**Issues Related to the Center for Automotive Research (CAR) December 15, 2010 Slide Presentation Entitled “The U.S. Auto Industry and the Market of 2025”**

March 9, 2011

The International Council on Clean Transportation (ICCT), with the assistance of Dan Meszler of Meszler Engineering Services, has reviewed the December 15, 2010 slide presentation entitled “The U.S. Auto Industry and the Market of 2025,” as prepared by the Center for Automotive Research (CAR). The following review is limited to the slide presentation alone as, to the best of our knowledge, there is no supporting report. As a result, in many instances the presented material was analyzed with an incomplete understanding of the methodologies used by CAR to arrive at the presented material. It is unlikely that the review suffers in any significant way from this limitation, but it is possible that incompletely documented statements may have been misinterpreted.

**Figure 1. NAS PHEV Report and DOE PHEV Battery Cost Estimates****Slide 13 (heading: none, discusses battery technology)**

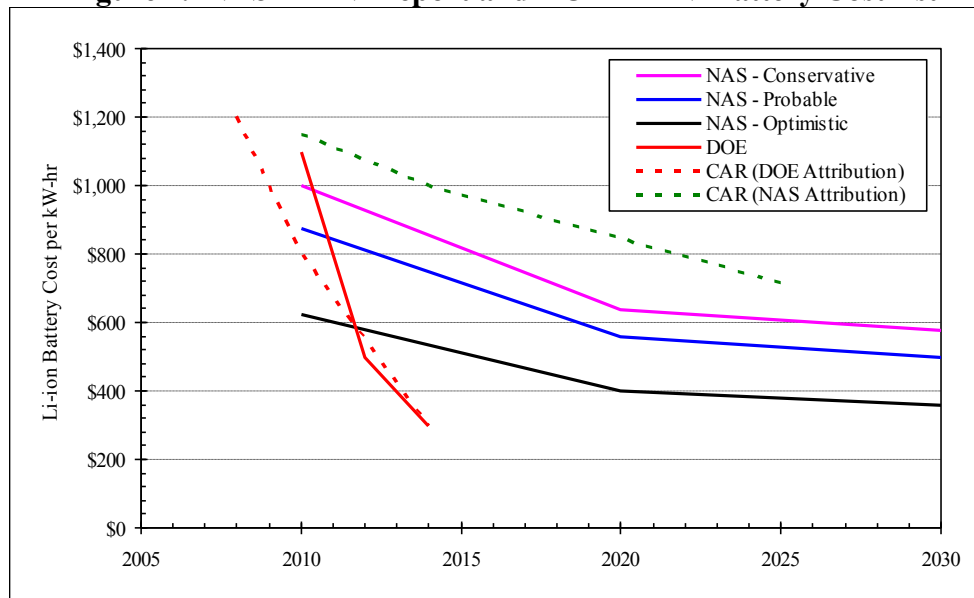
To claim that NAS sees no potential for significant battery cost reductions is simply unfounded. In fact, as shown in Figure 1, by 2025 the optimistic case cost assumptions of the NAS plug-in HEV report are quite similar to those of the DOE -- they just accrue over a longer timeline. It is clear that battery progress is continuing and while it is not possible to forecast future costs with certainty, it is misleading to characterize this area of research as likely to be unfruitful over the next 15 years.

**Figure 2. Summary of Costs and Benefits, Extended Scale**

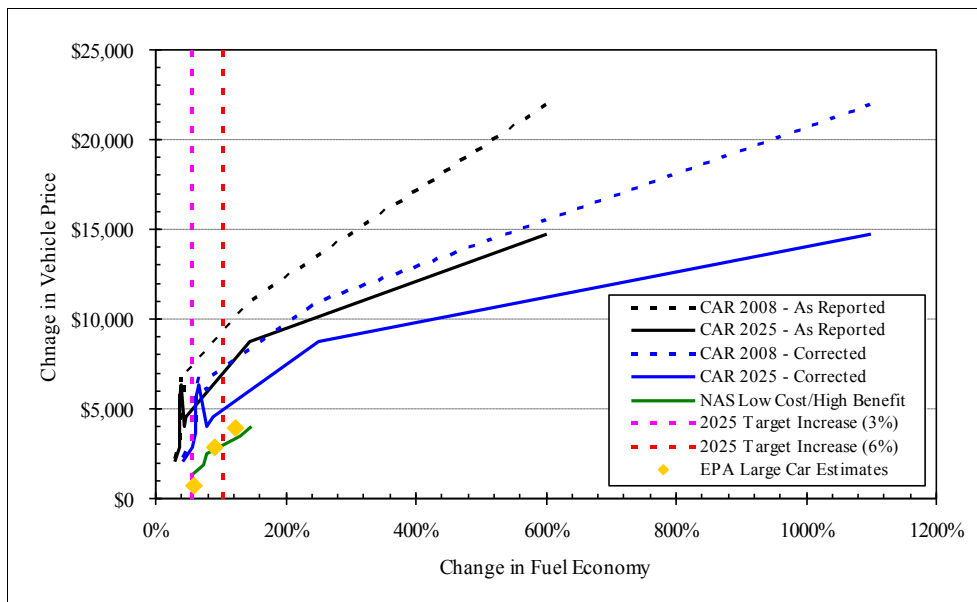
The key points related to the impropriety of the presented data were summarized, above, in the section on slide 15, Figures 2 and 3 simply recreate CAR's chart using only the corrections to the CAR data and the other relevant data from the slide 15 discussion above (i.e. the other corrections discussed above are not included in Figures 2 and 3). Two versions of the chart are shown. Figure 2 is presented solely to emphasize the visual distortion created by CAR's use of a skewed x-axis. Figure 3 (the same chart but with restricted axes) is provided to show the "important" range of the data on a continuous x-axis scale. The reduced costs and extended fuel economy impact range of the corrected SI and HEV data are obvious. Simply correcting the use of fuel consumption reductions as fuel economy increases drops the cost of complying with a given level of fuel consumption by more than 25%. Also using benefit and cost data representative of 2025, instead of current benefits and costs, drops the cost of complying by well over 50%.
